ENGINEERING CHANGE NOTICE

1. ECN 649913

13a. Description of Change  
DOE released an interim advisory on straight winds in January 1998. This revision addresses the impact of the advisory on wind-speed design criteria.

# Natural Phenomena Hazards, Hanford Site, Washington

Figure 4b. Hanford Meteorological Tower Peak Gust and Extreme Wind Speed Analysis (Ramsdell 1998).

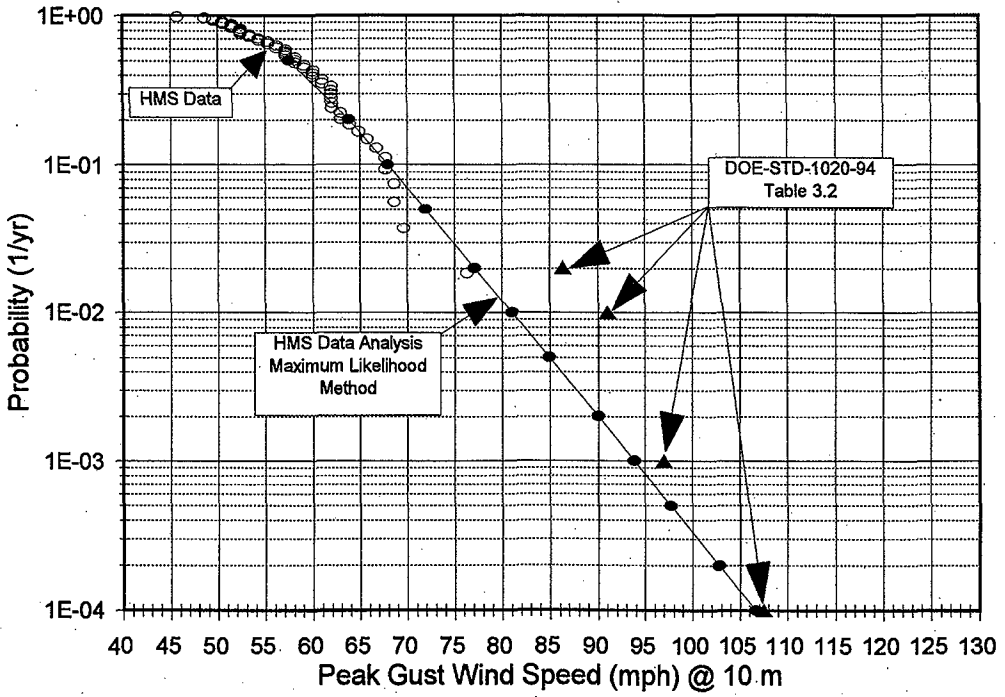
DOE released the *Interim Advisory on Straight Winds* (Advisory) (DOE 1998), which included the conversion from fastest-mile to peak gust wind speeds, in accordance with ASCE 7-95. The Advisory also provided revised peak gust wind speeds for the various performance category mean annual exceedance probabilities. The recommendations for lower probability wind speeds were based on generic conversion factors from Table C6-5 of ASCE 7-95, not on the site-specific wind hazard estimates. The recommendations for Performance Categories 3 and 4 are higher than current criteria and also exceed the Ramsdell (1998) study.

Work done by Peterka and Shahid (1992) was the basis for the ASCE 7-95 wind speed recommendations. Wind data from the Hanford Site were not included in their analysis. The results of the Hanford Site data analysis (Ramsdell 1998) show that the design wind speeds recommended in the Advisory (1998) and ASCE 7-95 are excessive for the Hanford Site.

The fastest-mile design wind-speeds at the Hanford Site are converted to peak gust wind speeds (Simiu and Scanlin 1996) and shown in Figure 4b. The design peak-gust wind speeds for Performance Category 1 are the same as those recommended in the Advisory. The Advisory increased the Performance Category 2 wind speed recommendation by 1.07 and reduced the importance factor from 1.07 to 1.0, resulting in no net change.

Based on the results of Ramsdell (1998) (Figure 4b), the DOE-STD-1020-94 (1994a) fastest-mile wind-speeds converted to peak gust for current straight wind are appropriate to use as the design criteria. The Performance Category 3 and Performance Category 4 values are conservatively rounded up to the nearest 5. The peak gust design criteria for Performance Categories 1 through 4 are shown in Table 3.
